**From:** DES ADATS-Wind Farm SME  
**Sent:** 27 October 2014 10:33  
**To:** DIO ODC-IPS SG2a  
**Subject:** RE: Hill of Lychrobbie wind turbines

**From:**  
**Subject: Hill of Lychrobbie wind turbines FAO**  
**Date:** 11 June 2014 17:12:12 GMT+01:00  
**To:** [DIOODC-IPSSG2a](mailto:DIOODC-IPSSG2a)  
**Cc:** ^

The attached plan shows our understanding of the local situation for reference (Burn of Whilk in red, operational turbines in blue, Hill of Lychrobbie in yellow).

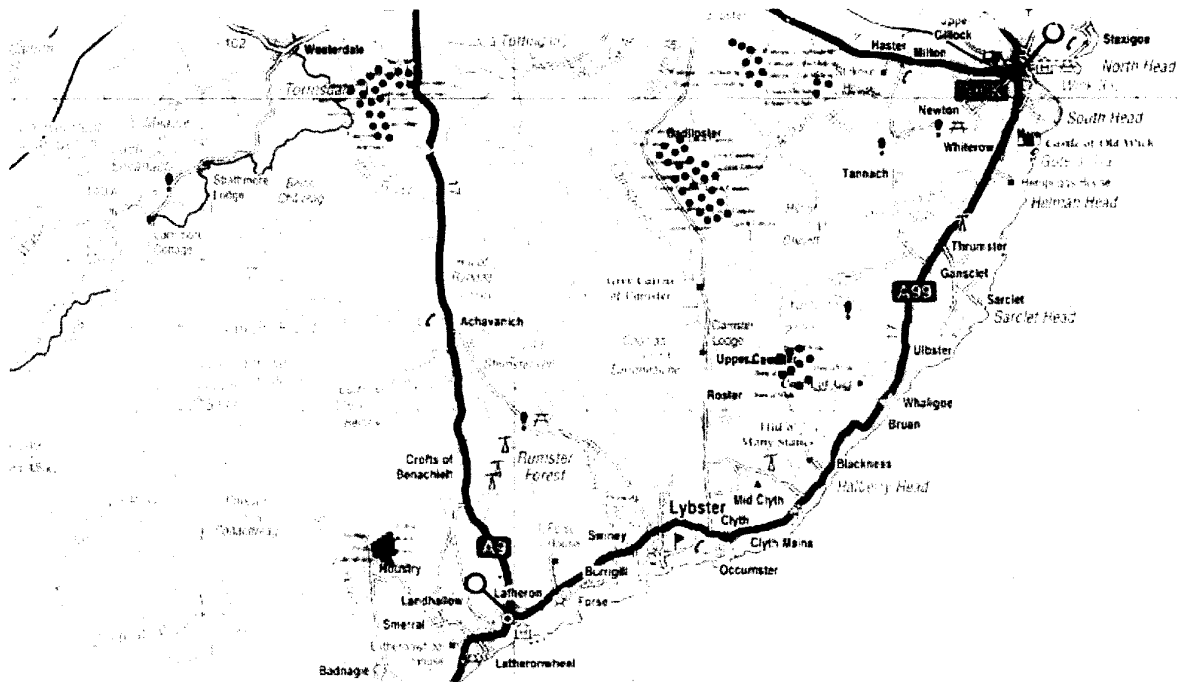
I understand that the review of RAF Lossiemouth by 1 Gp Safeguarding SMEs in May 14 identified issues with the operational turbines in the vicinity of the Burn of Whilk development, which is currently under construction. It seems to us that the operational impact of the Houstry / Buolfruich turbines, about 3km north of Lychrobbie, is equally if not more relevant to our project. Given that the SMEs presumably assessed Houstry / Buolfruich during their review of RAF Lossiemouth, we'd appreciate a summary of their conclusions.

The other follow up question I had was whether mitigating the detectability of the Hill of Lychrobbie project could be possible and might address operational concerns. We may be able to line up the turbines for example so they 'hide' behind each other when viewed from the radar, or drop from 3 to 2 turbines if that made a difference to the returns / interference.

I can't really see any proposed mitigation in the email, dropping the number of turbines isn't a technical mitigation so the operators would need to decide if one less turbine was acceptable.

Given my experience of observing wind turbines on radar displays I don't believe that it would be possible to 'hide' turbines behind one another. If the turbines were aligned to always face the radar, their rotation was precisely synchronised and the second turbine was within the radar shadow of the first one then it may be that a single return would be observed. In this configuration however it is also likely that the radar shadow would extend much further than for a single turbine.
